**BEFORE THE PUBLIC UTILITIES COMMISSION OF THE
STATE OF CALIFORNIA**

In the Matter of the Application of) Application No. 07-04-028
SOUTHERN CALIFORNIA EDISON)
COMPANY (U338E) for a Permit to) (Filed April 30, 2007)
Construct Electrical Facilities with Voltages)
between 50 kV and 200 kV:)
Fogarty Substation Project.)

In the Matter of the Application of) Application No. 07-01-031
SOUTHERN CALIFORNIA EDISON)
COMPANY (U338E) for a Permit to) (Filed January 16, 2007)
Construct Electrical Facilities with Voltages)
between 50 kV and 200 kV:)
Valley-Ivyglen 115 kV Subtransmission Line)
Project)

PROJECT MODIFICATION REPORT
SOUTHERN CALIFORNIA EDISON COMPANY (U 338-E) PETITION FOR
MODIFICATION OF DECISION 10-08-009

Figure 2-8: Light Weight Steel Pole with Fiber Optic Cable Typical Drawing

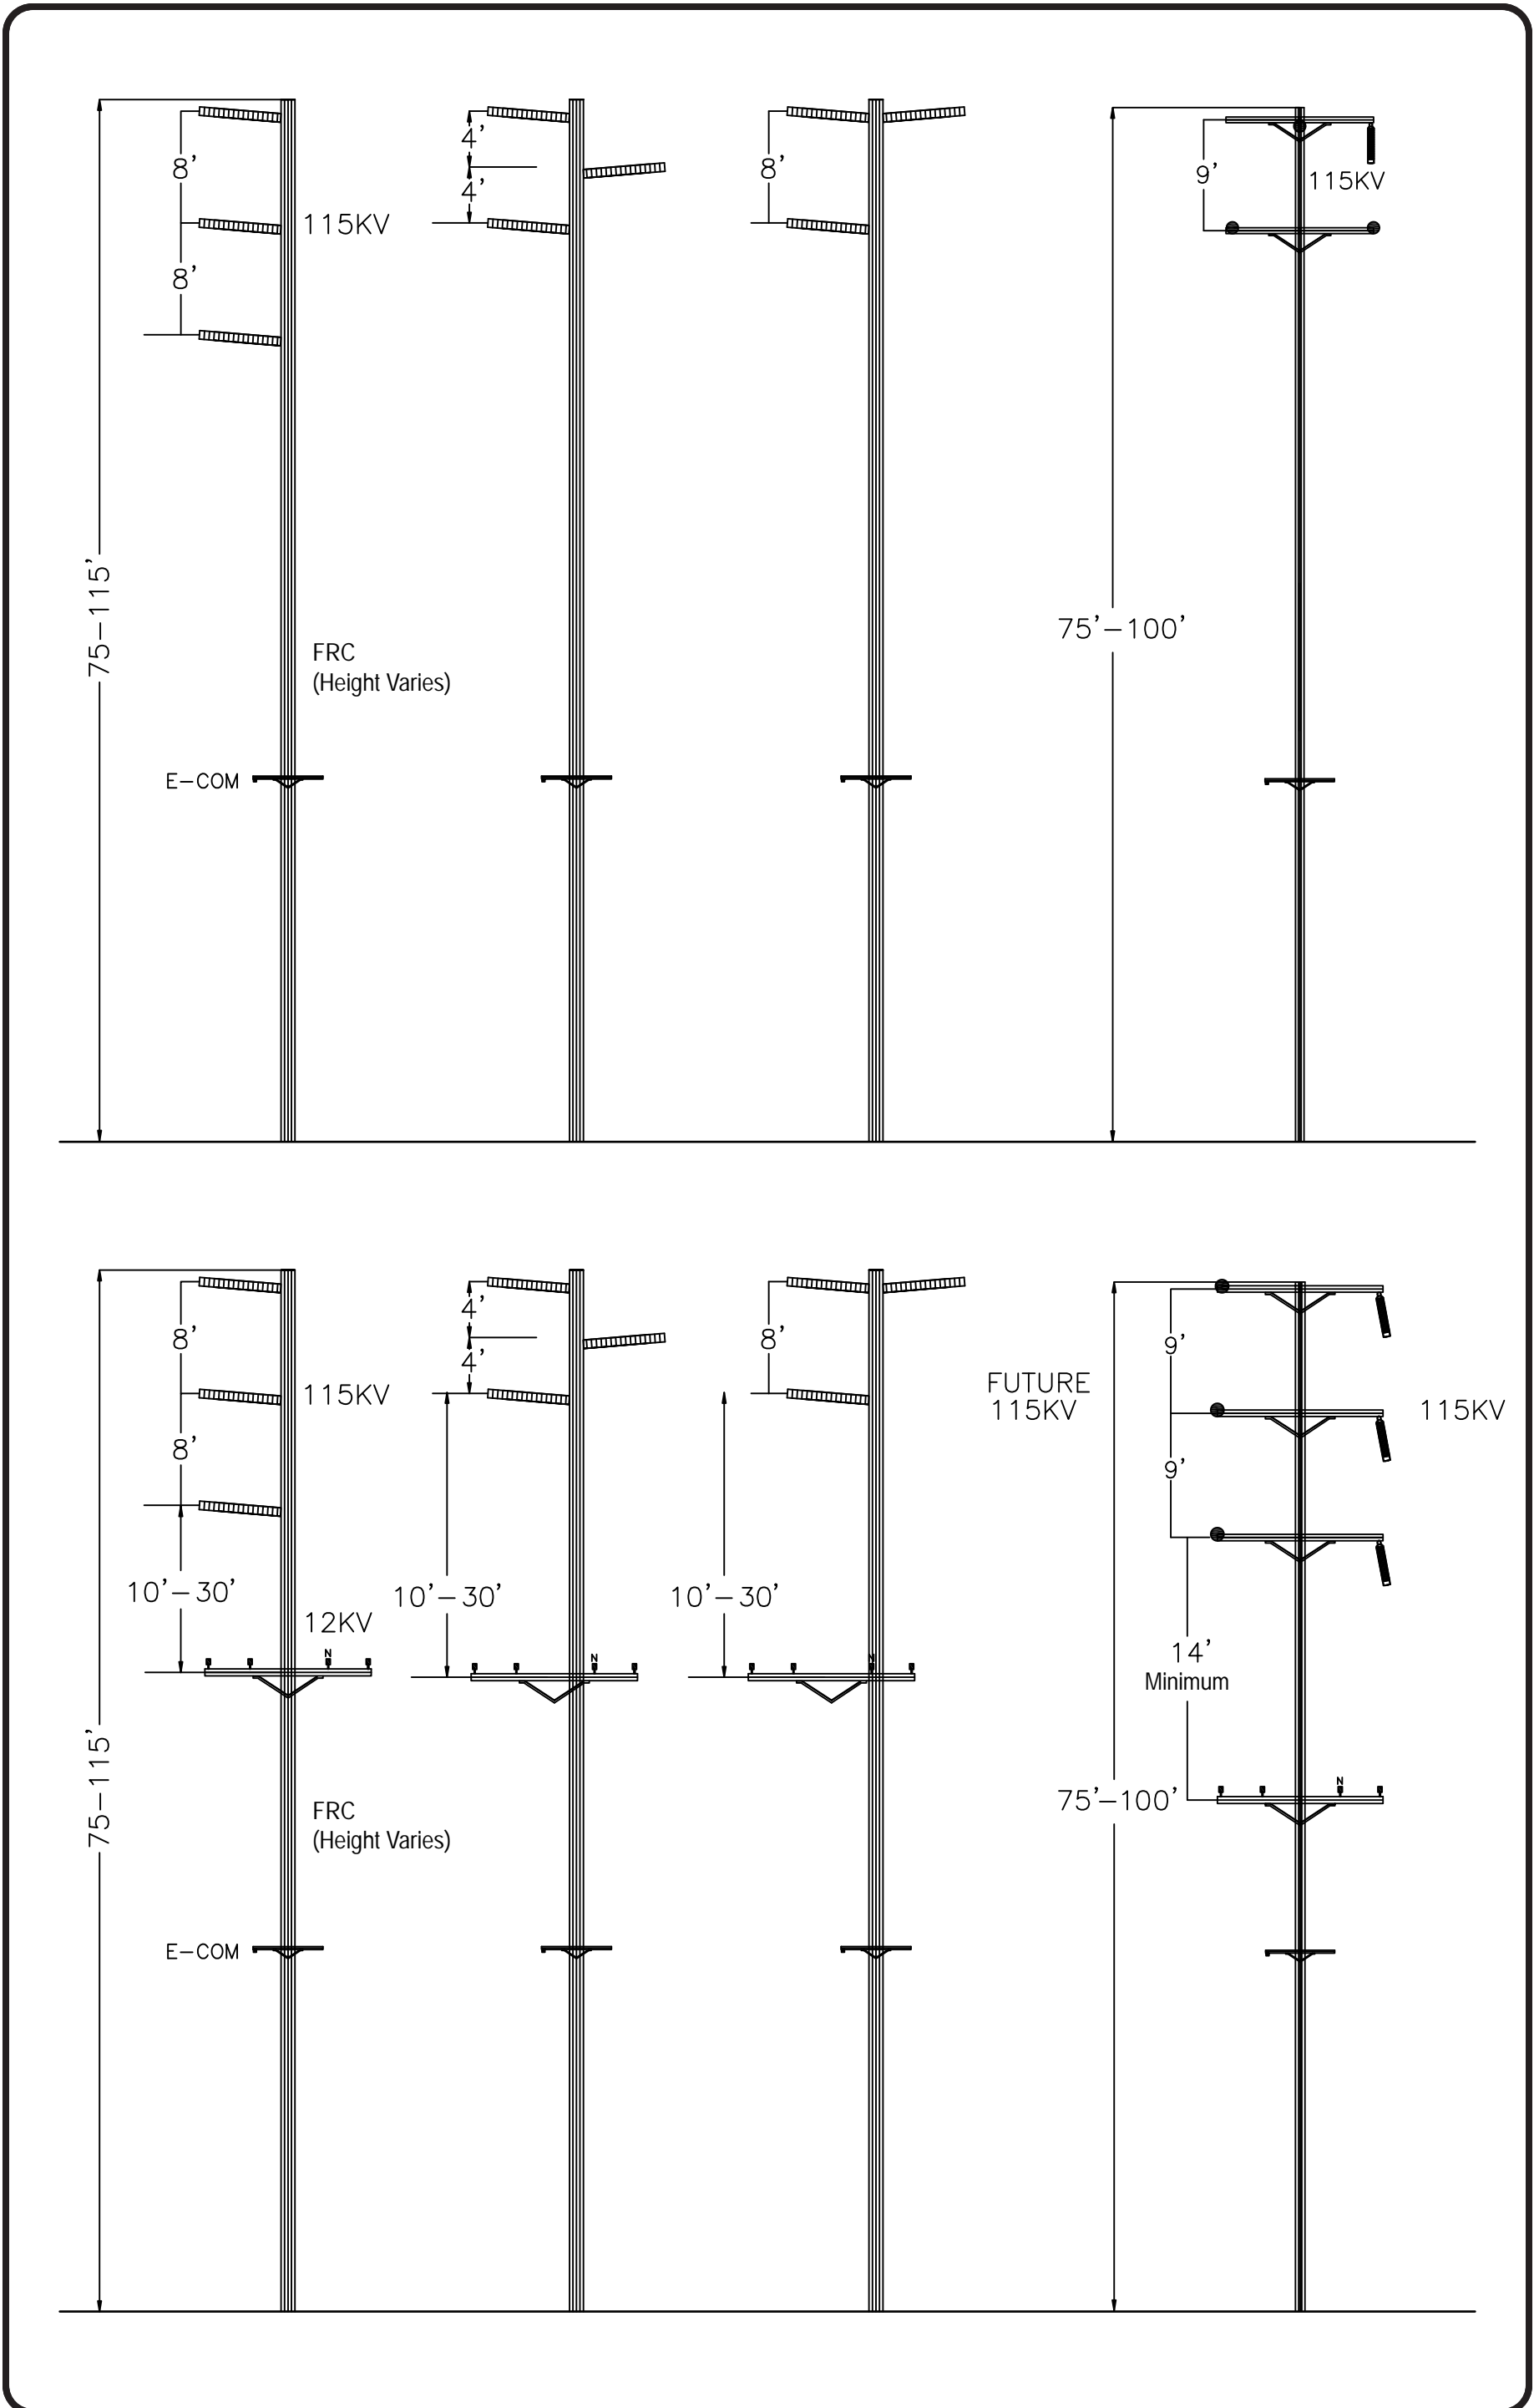
SCE is proposing to install approximately 21.6 miles of fiber optic cable on wood crossarms attached to the poles between Valley Substation and Ivyglen Substation. The wood crossarms would be approximately five or 10 feet by five inches by four inches. *Figure 2-8: Light Weight Steel Pole with Fiber Optic Cable Typical Drawing* and *Figure 2-9: Tubular Steel Pole with Fiber Optic Cable Typical Drawing* provide typical drawings of LWSPs and TSPs with fiber optic cable attached on wood crossarms. The locations of the overhead fiber optic cables are depicted in *Figure 2-7: Telecommunications System Overview Map*.
